Evaluation of Adopted Flow Standards for the Trinity River, Phase 2

For: Trinity and San Jacinto Rivers and Galveston Bay Stakeholder Committee through the Texas Water Development Board

Contract No. 1600011940
Final Report – November 2017

Figure 48. Changes in cross-section at station 3849.9.

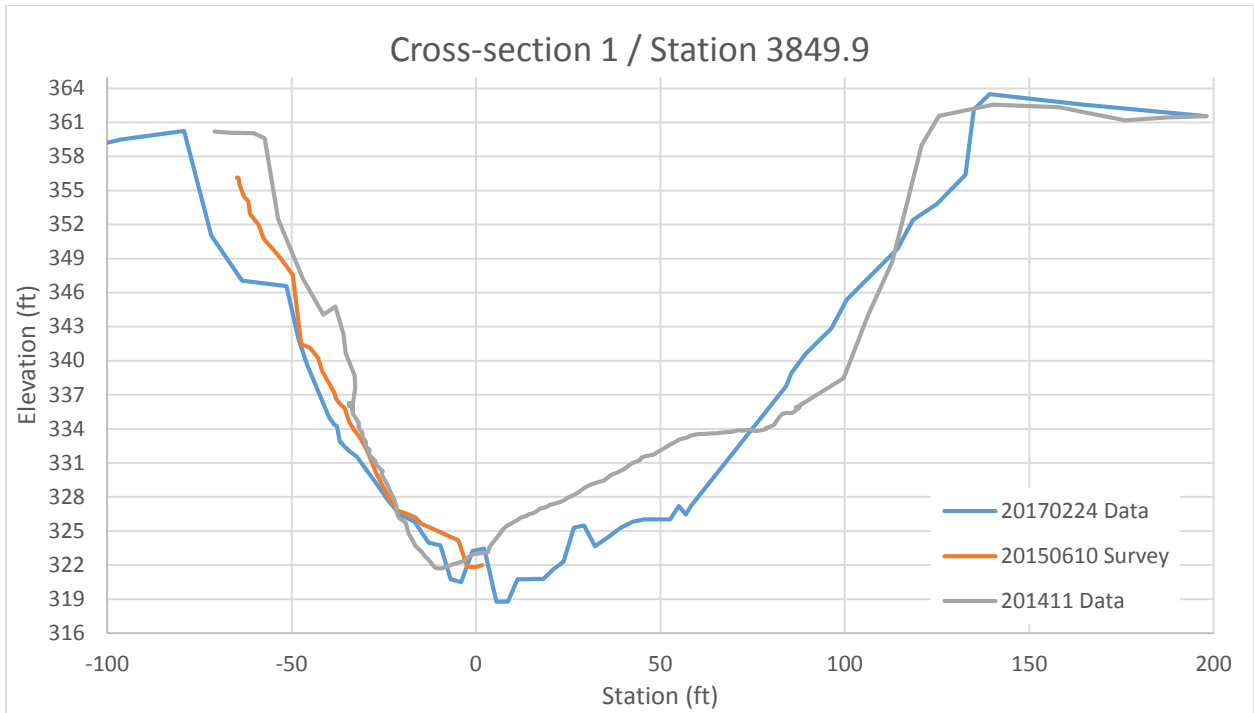
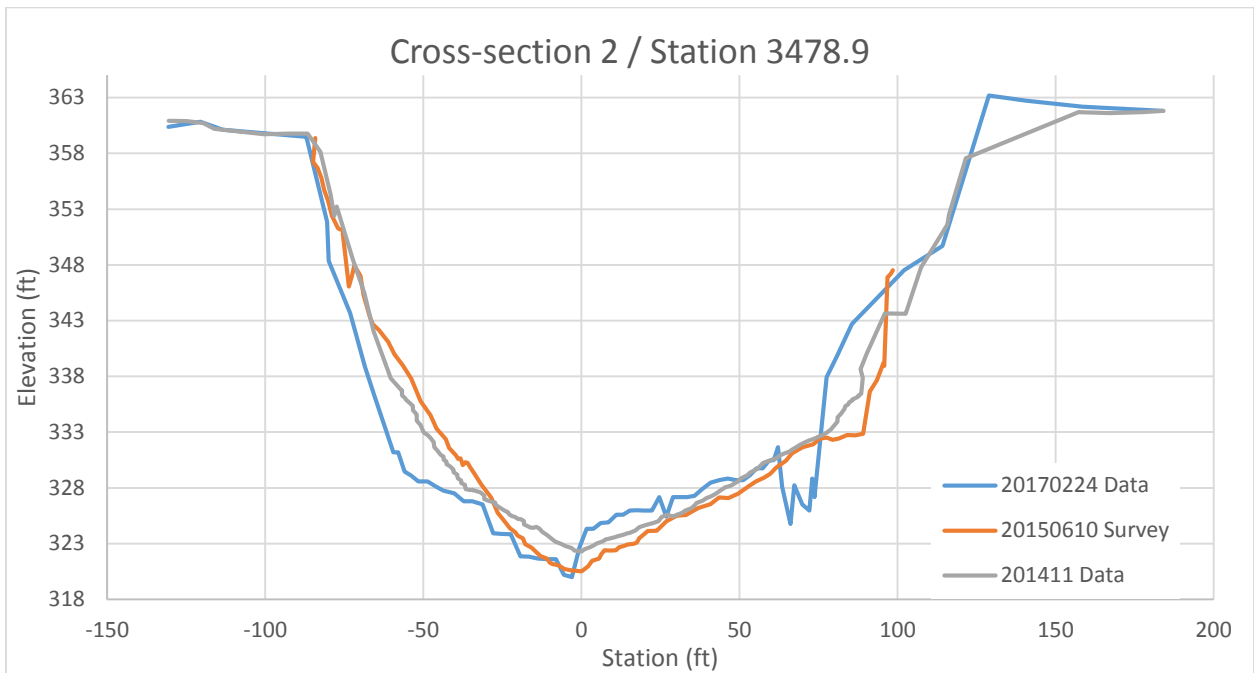
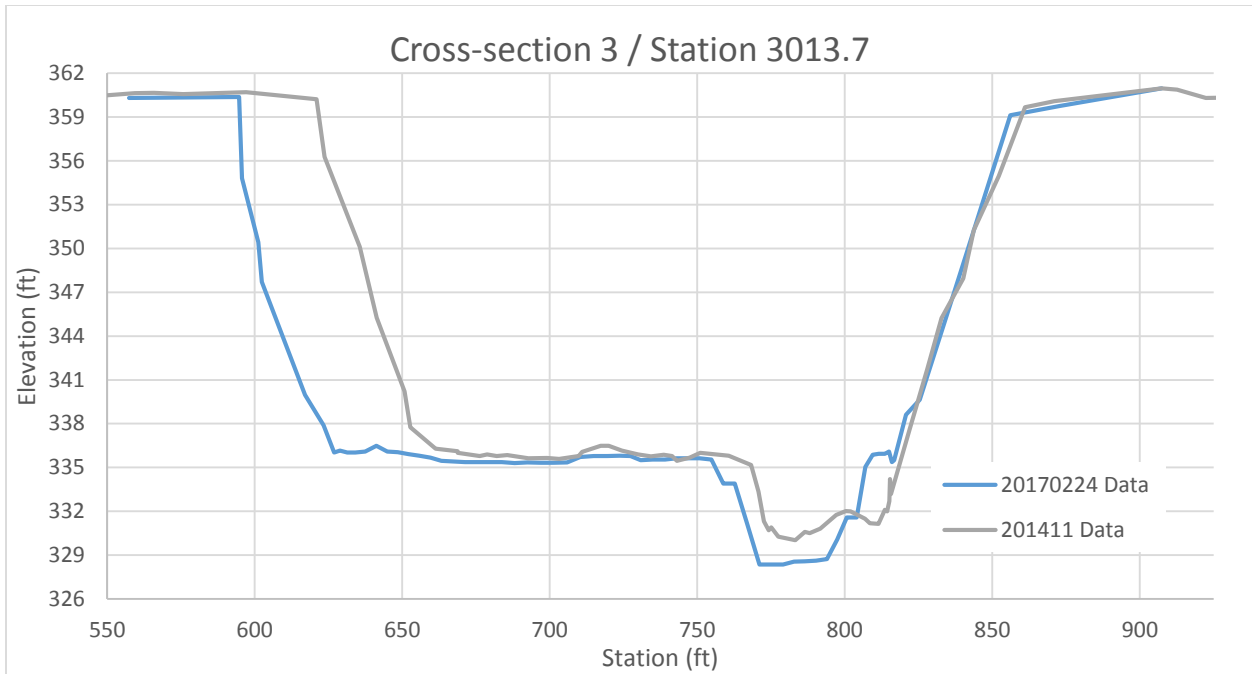
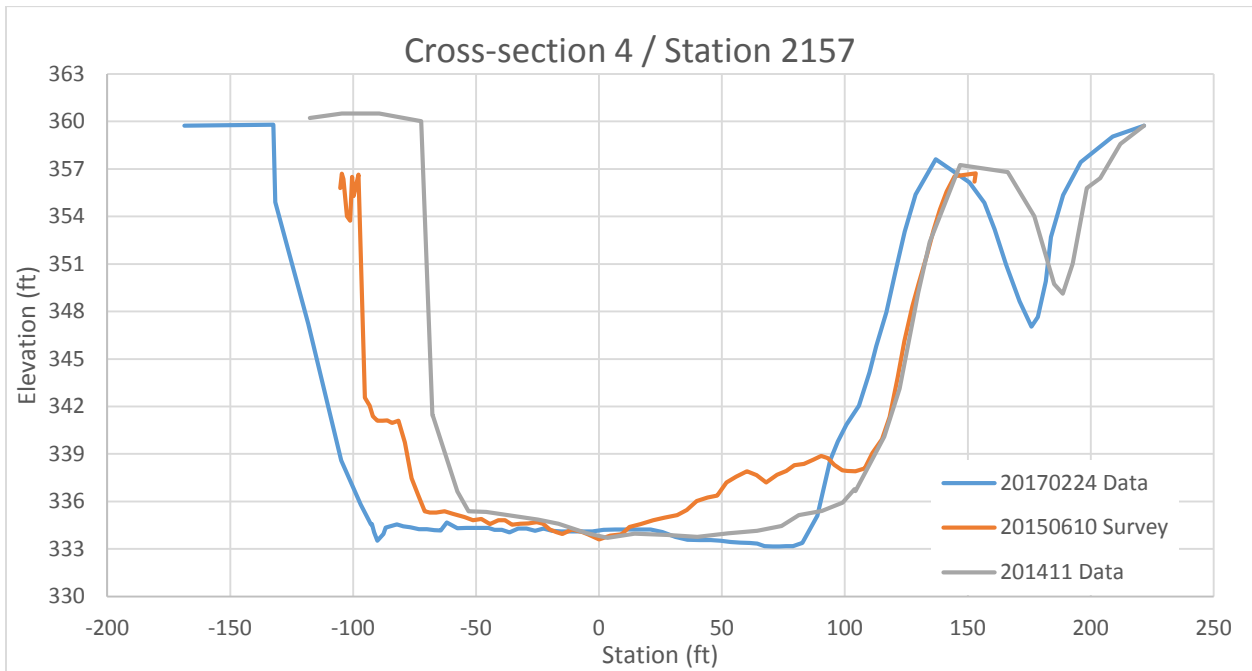
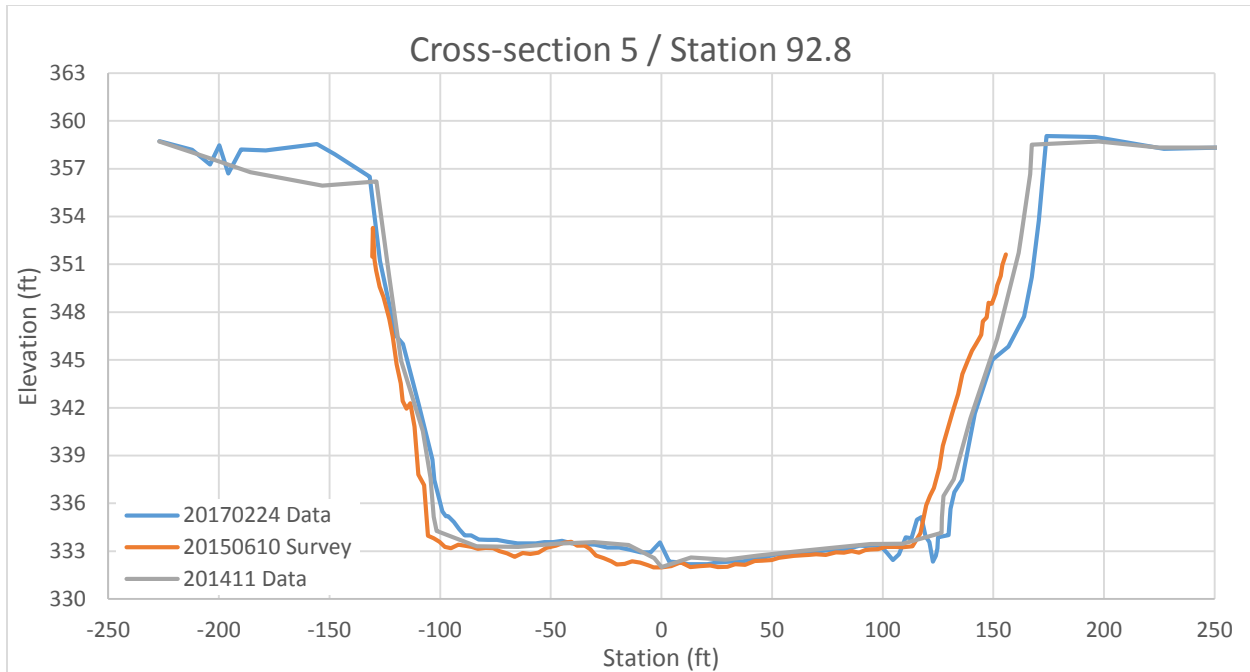
17. On page 61, 1st paragraph, 1st sentence, please provide the citation mentioned in the text. - **Done**
18. It appears that lines in Figures 47 to 51, 60-62, 74-78, and 100-112 are being artificially smoothed by the plotting software. Please insure that point-to-point data is being plotted in these figures by turning off any data smoothing options (such as “Smoothed line” in Microsoft Excel). – **Done**
